**Land between 26 Gordon Square and
15 Gordon Street, London NW1H**

**Basement Impact Assessment
Audit**

London Borough of Camden

Project Number: 12066-24
Rev: F1

Figure 2 - Site with surrounding buildings and sections where ground movement has been calculated

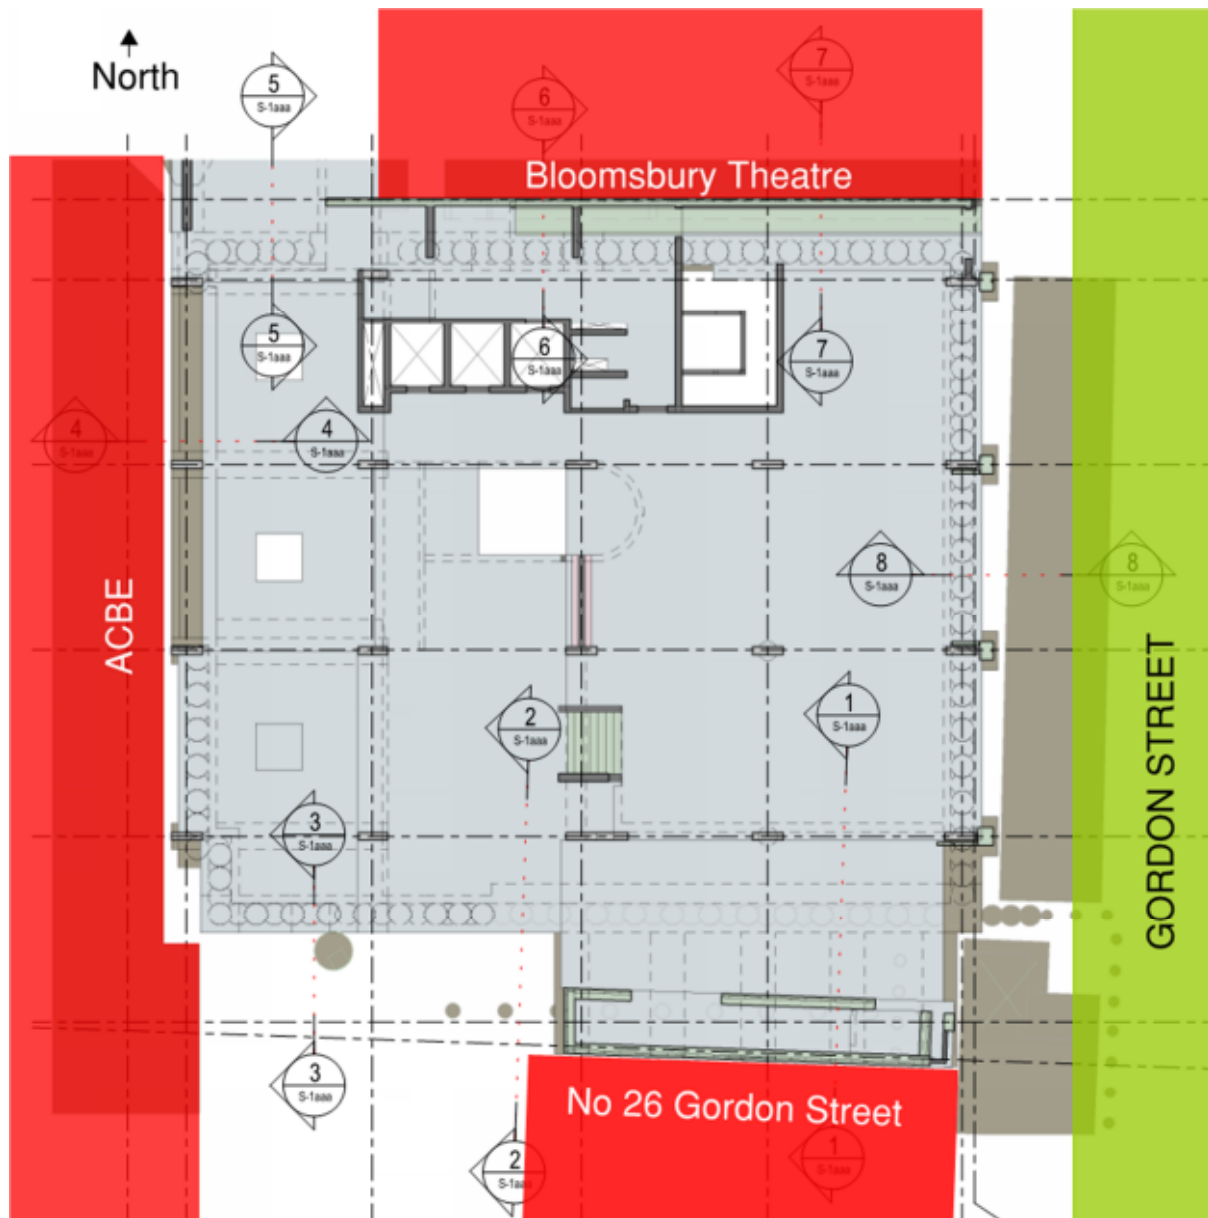
- Expanded looked at 8 different sections of basement and Curtins note that 3 are not significant. There is no orientation on the plan or indication of surrounding buildings to demonstrate that.

- Expanded looked at 8 different sections of basement and Curtins note that 3 are not significant. There is no orientation on the plan or indication of surrounding buildings to demonstrate that.

On the second point I have attached a mark-up of the plan with the 8 sections and indication of the orientation, this should help to better understand which section applies where.
